PRODUCT ADVISORY

**Data Sheet Specification Change for
Intersil Products ISL59601*,
ISL59602*, ISL59603*, ISL59604*,
and ISL59605***

**Refer to:
PA12072**

Date: September 6, 2012

- Figure 45 – Application Circuit for UTP Cable (Page 20):

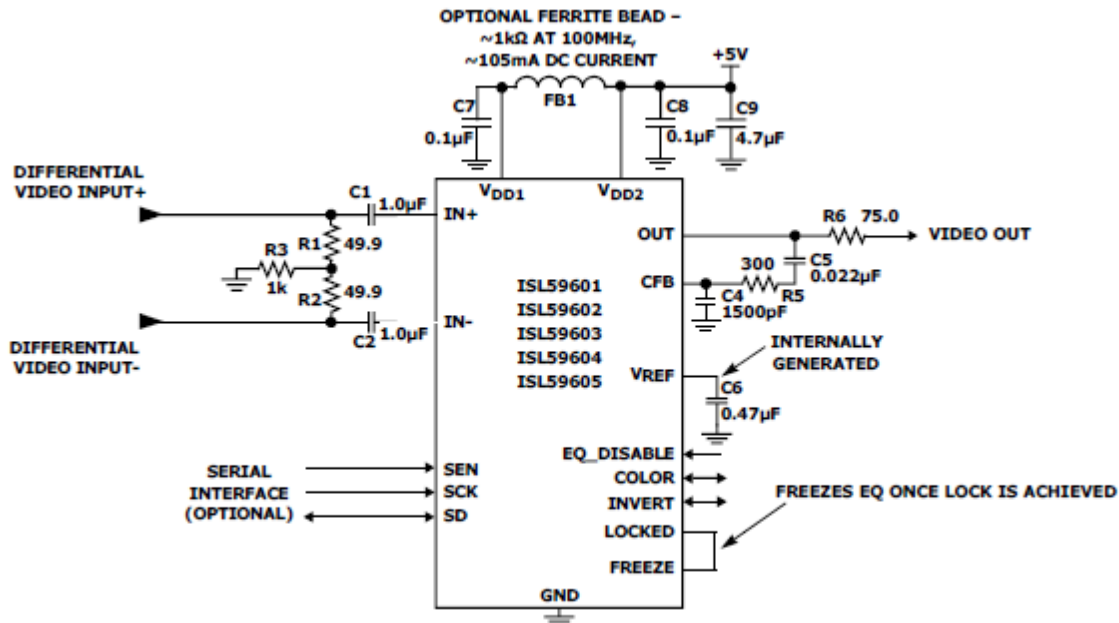
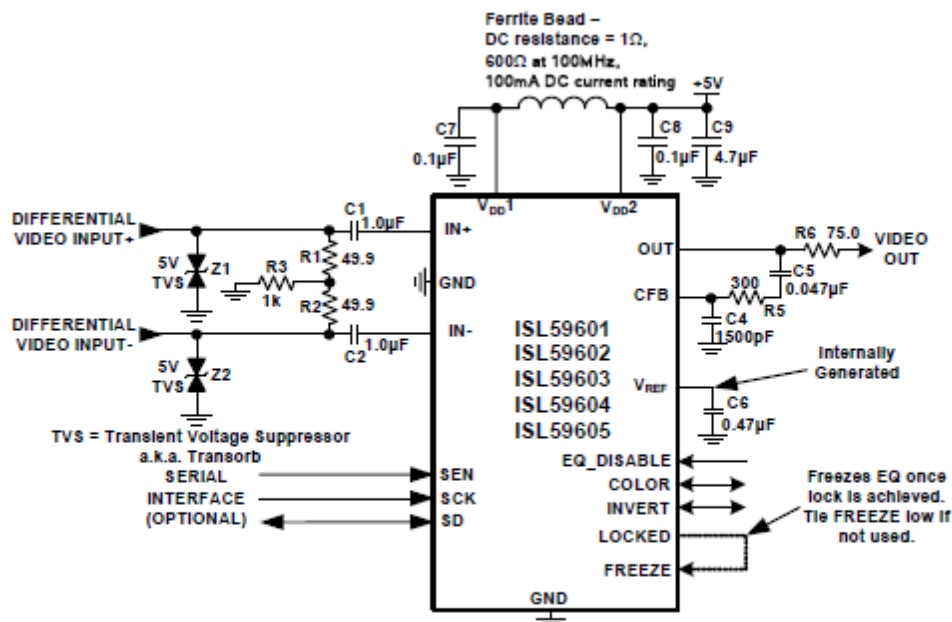
This advisory is to inform you that Intersil has made an enhancement to the data sheet application circuits for the listed ISL59601*, ISL59602*, ISL59603*, ISL59604*, and ISL59605* products. Although the current application circuitry is functionally correct, the update will improve Intersil's product performance. The changes affect the termination requirements outlined in the *Figure 45 – Application Circuit for UTP Cable*, *Figure 46 – Application Circuit for COAX Cable*, *Figure 47 – Application Circuit for UTP/COAX Cable*, and verbiage in the related sections. Details regarding the changes to the figures are contained on the following pages. The updated data sheet is available on the Intersil web site at <http://www.intersil.com/content/dam/Intersil/documents/fn67/fn6739.pdf>.
